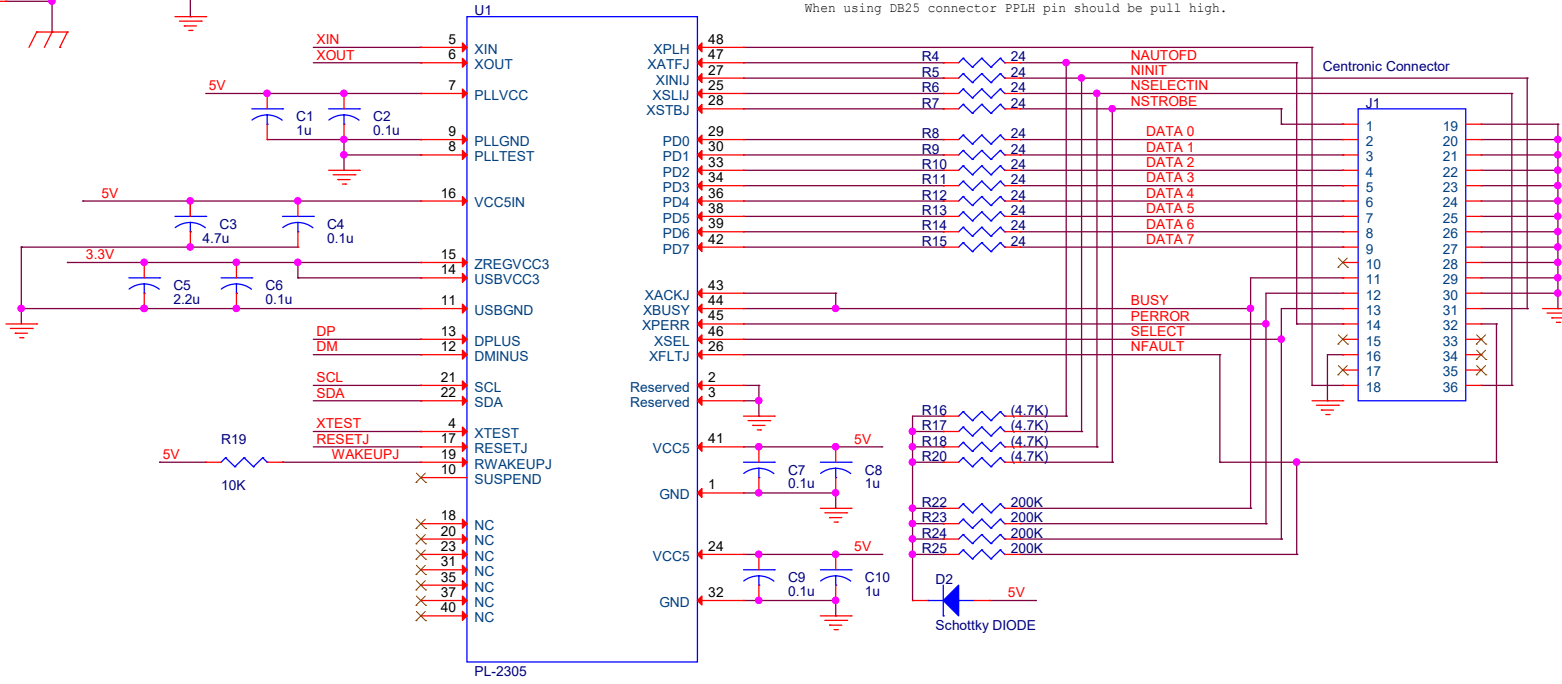
When using DB25 connector PPLH pin should be pull high.

C8 should be placed close to U3

Note: VCC for 24C02 is 5V, not 3.3V

The traces inside this block should be wider. And, this circuit should be placed close to U1
